ADDENDUM NO. 1

Project: Beatrice State Developmental Center

Building #15 Roof Replacement

Issued: March 20, 2014

ATTACHMENT 1

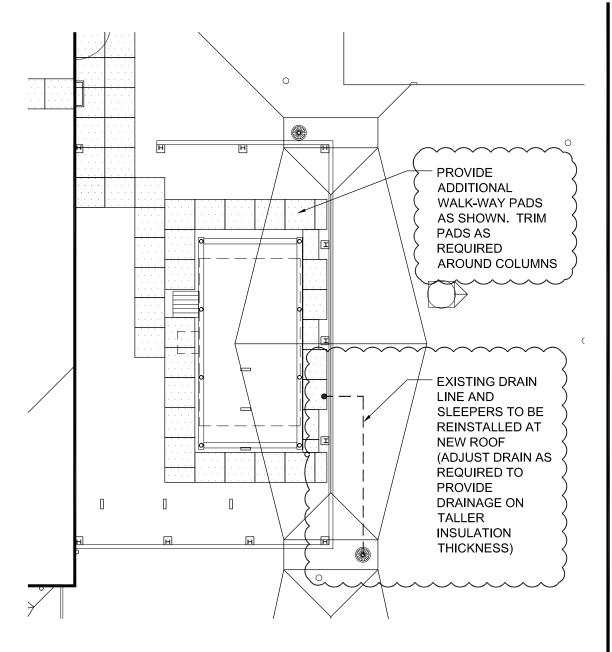
AD1.3. Refer to Attachment 1 for existing drain line; clarification regarding drain line not

shown in original documents.

<u>AD1.4.</u> <u>Update regarding walkway pads</u>: Provide additional walkway pads as shown on

Attachment 1.

ATTACHMENT 2

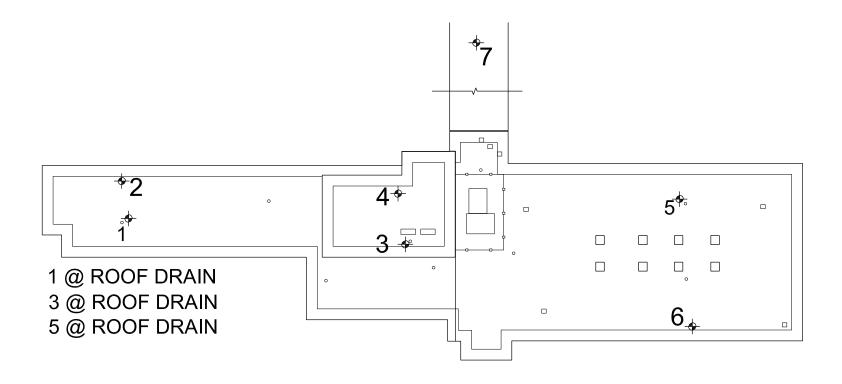
<u>Existing Roofing Core Samples</u>: Please refer to Attachment 2 for the 7 locations of existing roof core samples taken during design. The results of these core samples are as follows:

Core 1: 45 mil EPDM on 2 layers of 1" iso, on concrete deck Core 2: 45 mil EPDM on 2 layers of 1" iso, on concrete deck Core 3: 45 mil EPDM on 2 layers of 1" iso, on concrete deck Core 4: 45 mil EPDM on 3 layers of 1" iso, on concrete deck Core 5: 45 mil EPDM on 2 layers of 1" iso, on concrete deck Core 6: 45 mil EPDM on 3 layers of 1" iso, on concrete deck Core 7: 45 mil EPDM on 2 layers of 1" iso, on concrete deck

ATTACHMENT 6

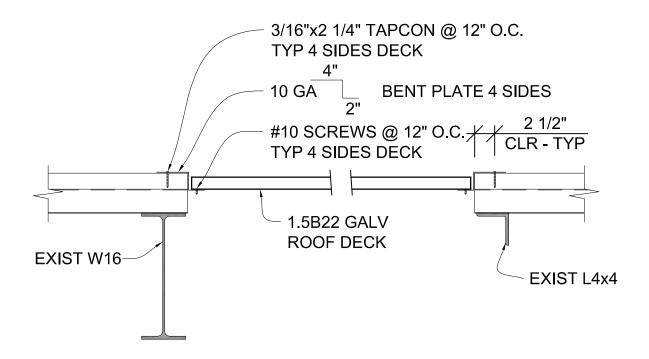
Revision regarding roof skylight infills: Refer to Attachment 6 enclosed for an updated skylight infill detail, allowing all construction to occur from on top of the roof.
